IOWA ELECTRIC LIGHT AND POWER COMPANY

March 9, 1976
IE-76-403

This submittal is to supplement our application dated May 30, 1975 and amended January 8, 1976 and February 13, 1976. The enclosed questions were transmitted to us orally by Mr. W. Paulson and Mr. H. Orrstein of your staff on February 26, 1976. Answers have been informally transmitted to your staff. This submittal is to provide written confirmation of those answers.

Attachment 1

SHEET NO. 22 OF 23

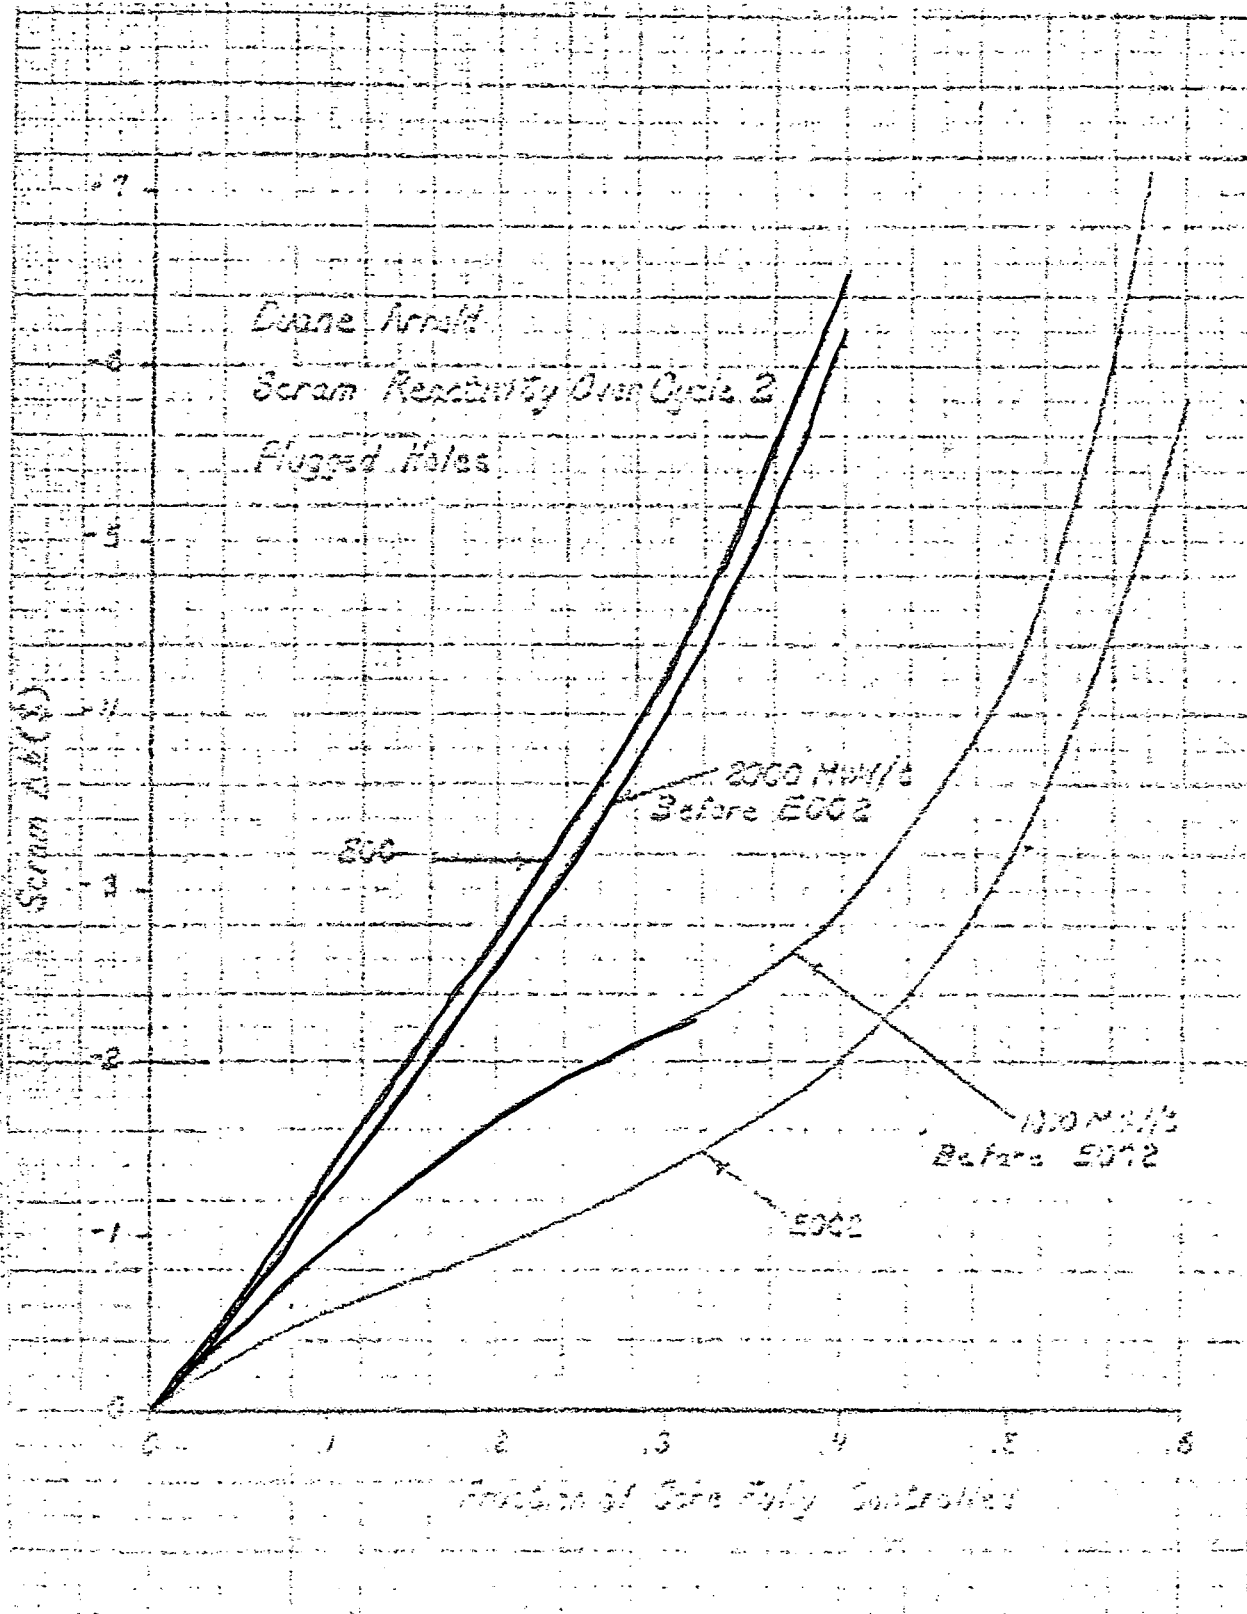
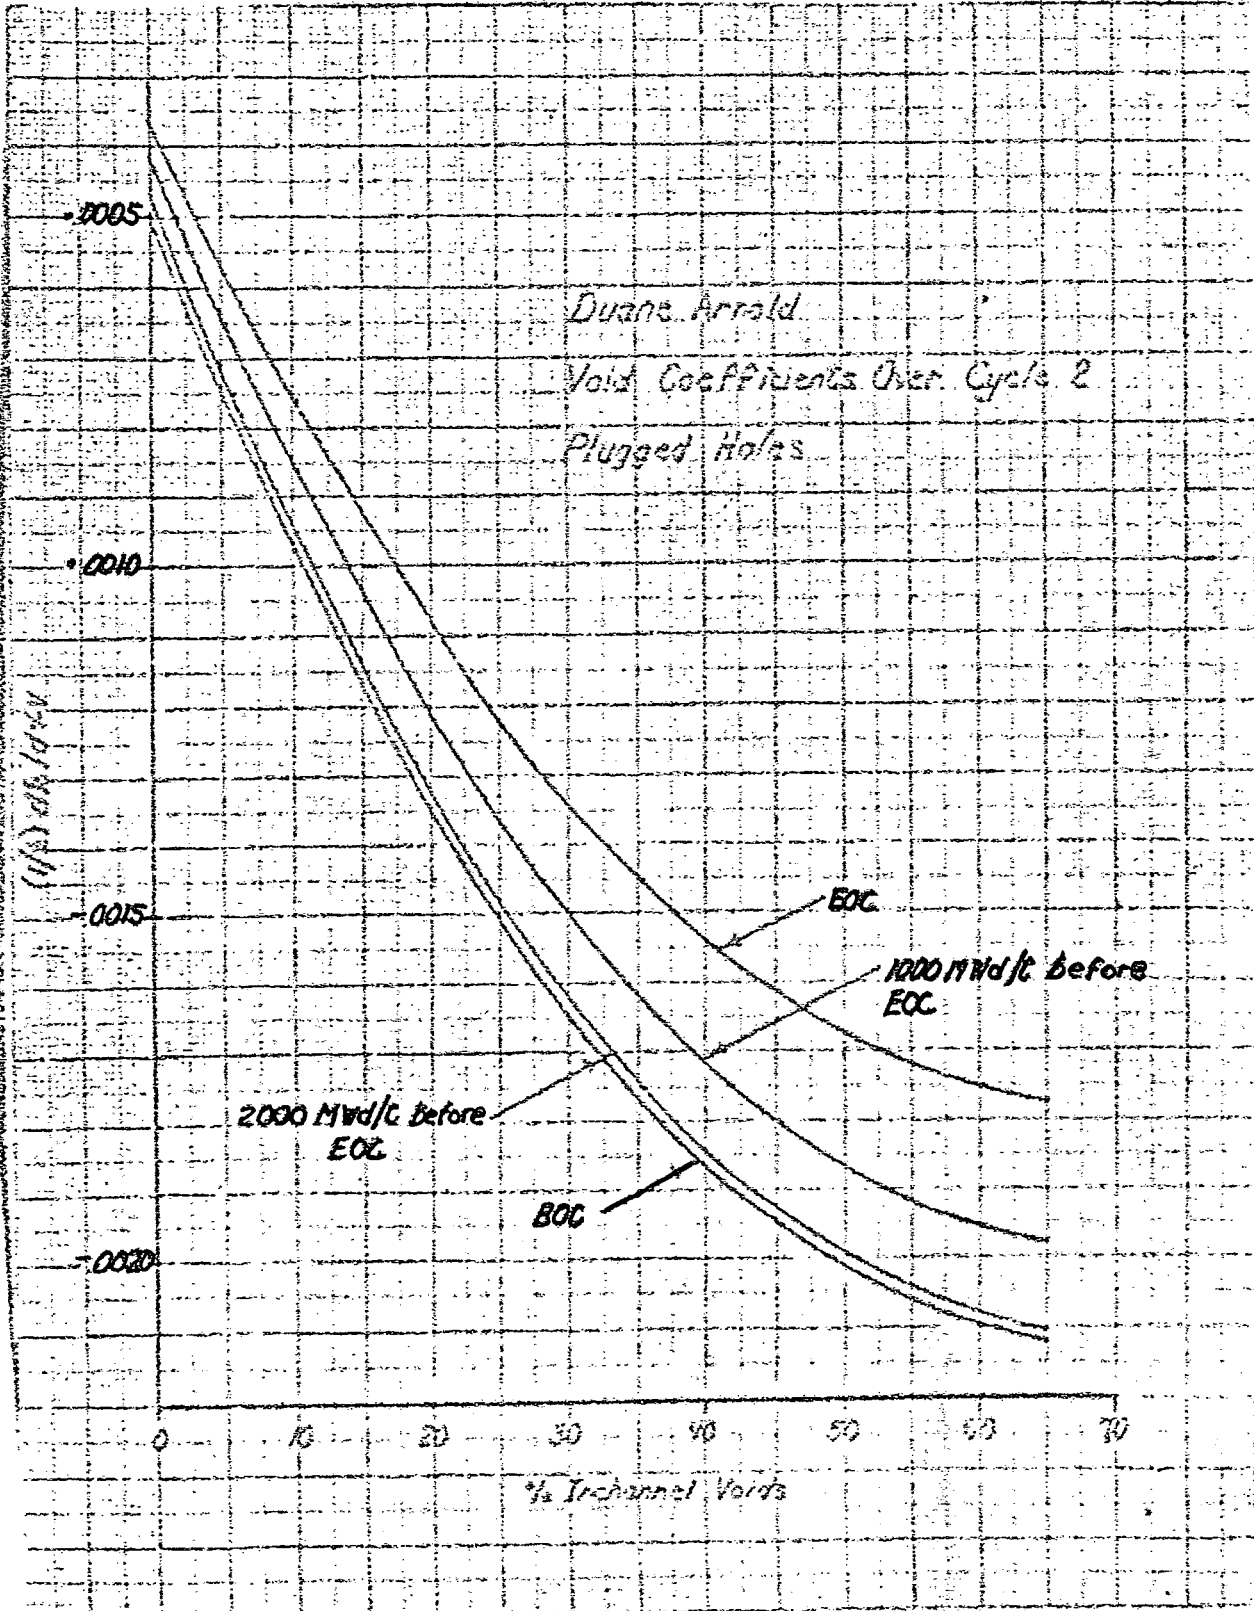
3. Please provide beginning of Cycle scram curves.

See Sheet Number 22 of General Electric document 384HA698 (Attached).
